SOURCE<sup>1</sup>: CopperGate CommunicationsTITLE: G.hn: Using Two Symbols for the Header of a PHY frame on Coax

**ABSTRACT**

The contribution proposes that the number of symbols used for the header of the PHY frame on coax (baseband and RF) be fixed to two exactly. The reason for this proposal is that a single symbol does not provide adequate reliability for the 50 MHz case, as shown below.

Figure 7-10/G.9960 – Functional diagram of the Header Encoder

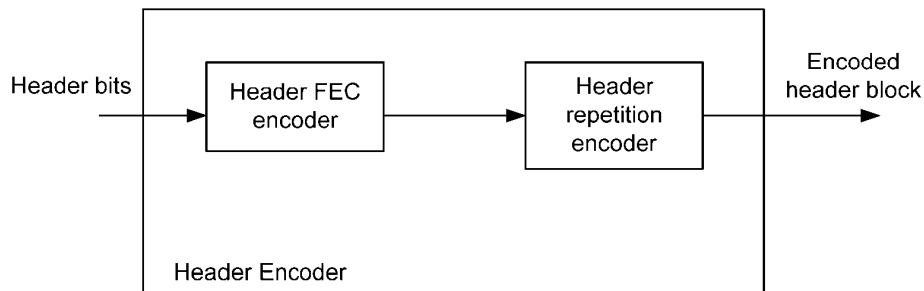
A straightforward calculation can be carried out in order to assess the required number of OFDM symbols. Let us consider the more challenging setting of 50 MHz devices on coax. Both for baseband and RF, the number of subcarriers is 256. Since the header is modulated using QPSK and rate 1/2 a single copy of the PHY-header FEC block takes 168 subcarriers. Obviously, there is only room for a single complete copy of the FEC block. This situation is problematic, because the header does not have any advantage over the payload in terms of robustness.

Decoding a 136-bit FEC block with a BLER level of  $10^{-6}$  requires an SNR of 5 dB or so. On the other hand, decoding a 520-byte FEC block with a BLER level of  $10^{-6}$  requires an SNR of about 3.5 dB – some 1.5 dB less.

It is reasonable to approximate that if there are  $N$  copies of a FEC block then it acquires an extra coding gain of  $10\log_{10}(N)$ , even if  $N$  is non integer. If we assume that 0.9 of the band is utilized then this means there are  $256 \times 0.9 / 168 = 1.4$  repetitions per symbol, which provide a gain of 1.5 dB. This

makes the header about as robust as a payload encoded using a FEC block of 520 bytes with code rate 1/2 and QPSK modulation.

This contribution proposes to *always* use two header symbols on coax. The number of subcarriers in two OFDM symbols is 512, which is barely sufficient to accommodate 3 full copies of the header, which require  $3 \times 168 = 504$  subcarriers. Note that in practice some guard bands are expected near the band edges. In this case, even 3 full repetitions will not fit in.

For coax (baseband and RF) the number of PHY-frame header shall be two, i.e.,  $D = 2$ .
